CITY PLANNING COMMISSION

- APPLICATION:**
- A. Negative Declaration
 - B. Special Permit to allow 100 percent office use for three buildings totaling 159,200± sq. ft. on 10.0 vacant acres in the M-1 zone.

PROPOSAL: The applicant is requesting the necessary entitlements to construct three 2-story office building.

65th ST. OFFICE
PARK

SITE PLAN

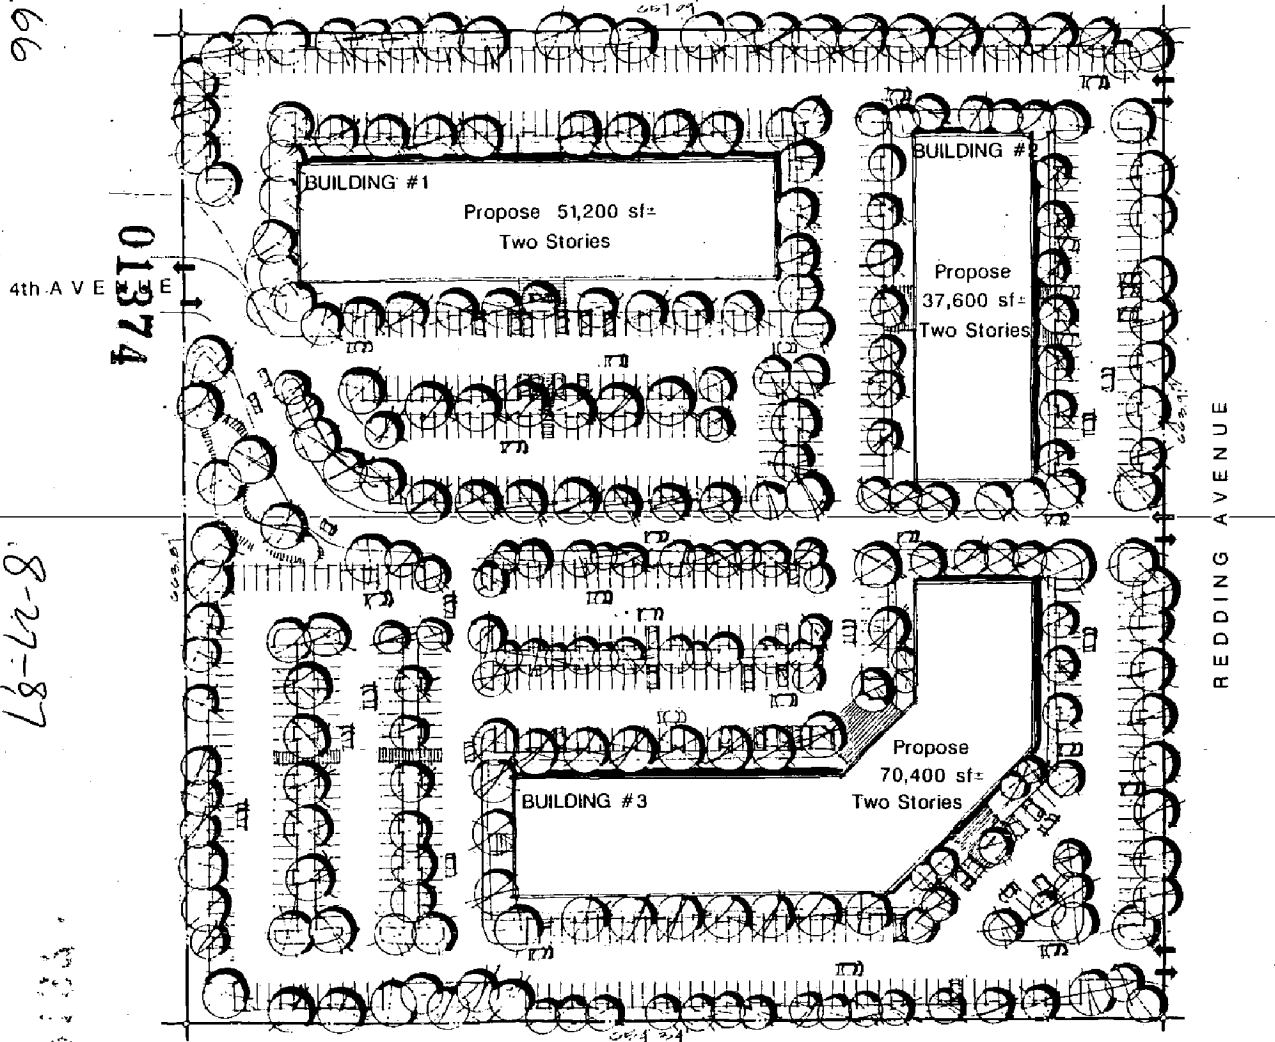
The site plan does not show the location of trash enclosures or the required Class I, II, bicycle storage lockers. The site plan needs to be revised to show the locations of the trash enclosures and bicycle storage lockers.

The building footprints proposed on the site plan do not precisely match the proposed building elevations. Staff recommends the site plan be revised to show more precise building footprints consistent with the proposed elevations.

There is a multiple Family (R-3) zone located along a portion of the west property line (see site plan). A six foot high solid masonry wall will be required along a portion of the west property line (see site plan).

Based upon the above comments, staff recommends revised site and elevations plans be submitted for the review and approval of the Planning Director prior to the issuance of a building permit.

- * 12. A revised site plan showing ~~the alignment~~ a cul-de-sac at 4th Avenue or extension of 4th Avenue or extension of 4th Avenue to Redding Avenue shall be submitted to Planning Staff for review and approval prior to the issuance of building permits. *Design shall comply with Public Works Department requirements. 50' R.O.W. w/ 400' R.*

- 15. A revised site plan indicating the alignment of Broadway to Redding Avenue shall be submitted to Planning Staff for review and approval prior to issuance of a building permit.

ELEVATIONS BUILDINGS 1 & 2

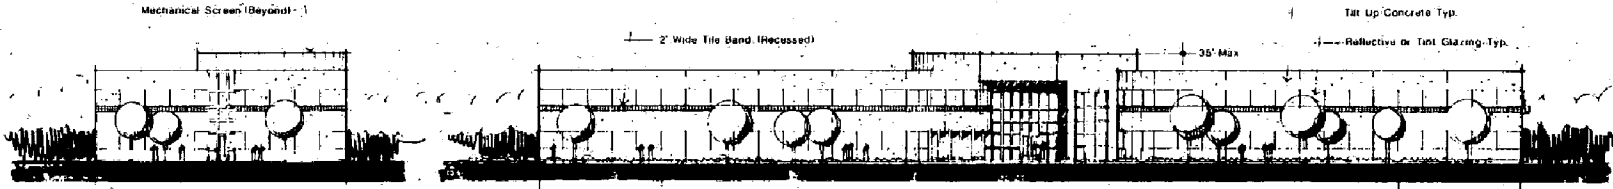
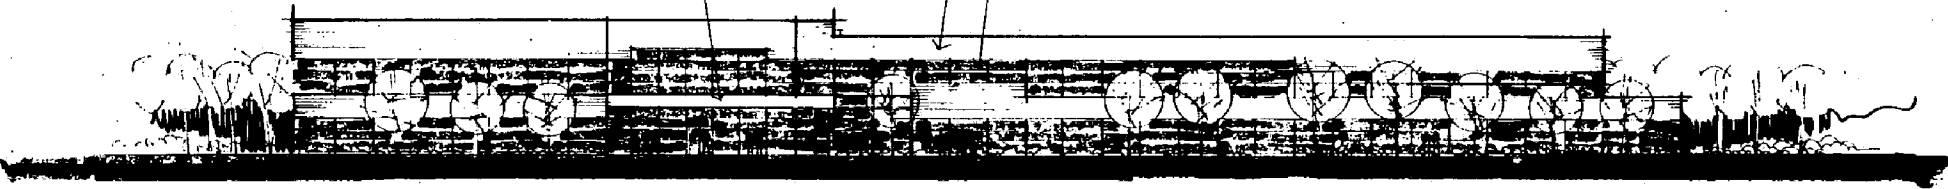
The elevations submitted show concrete tilt-up panels, tint or reflective glass and recessed entry or entry canopy. However, the elevations submitted do not provide sufficient detail and are more conceptual rather than specific. Staff has concerns with the flat lineal facade and would prefer to see more movement both horizontally and vertically in all elevations.

The proposed design of the entry areas for both front and rear of the buildings are different. Staff recommends these entry ways be redesigned so they are the same.

Staff recommends all roof top equipment be screened from public view.

The exterior building materials proposed are generally acceptable. However, staff recommends the additional use of brick, tile, insets or other textural elements be added to the proposed building materials.
